<b>T.I. no.: 2019 - 02</b> Updated: -	<b>Topic: SCClub Software 1.6.4</b>
--	-------------------------------------

<b>Date: 24.01.2019</b>	<b>Priority</b>	<b>Need for action</b>
<b>Affected machines: SCClub</b>	High	As soon as possible
<b>From serial number: -</b>	Medium	On next visit to the machine
<b>As of date: -</b>	X Low	X FYI only

## Time zone and daylight saving time can be set

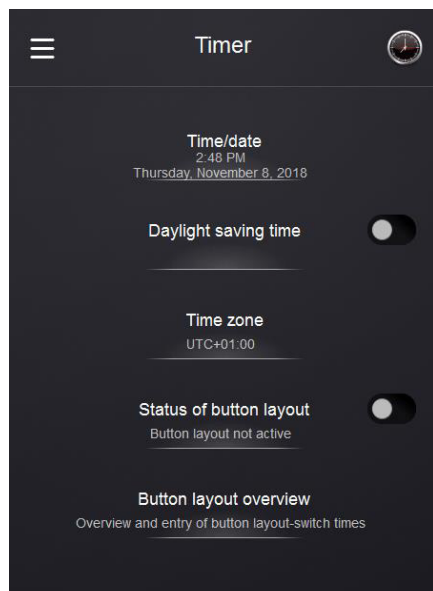
It is now possible to set the time zone and automatic changeover to daylight saving time.

The advantage of this is that the time on the coffee machine is automatically changed to daylight saving or winter time. The "Daylight saving time" setting is deactivated by default, meaning the automatic daylight saving/winter changeover is active.

The setting options are available both when commissioning new machines and later on using the Timer menu.
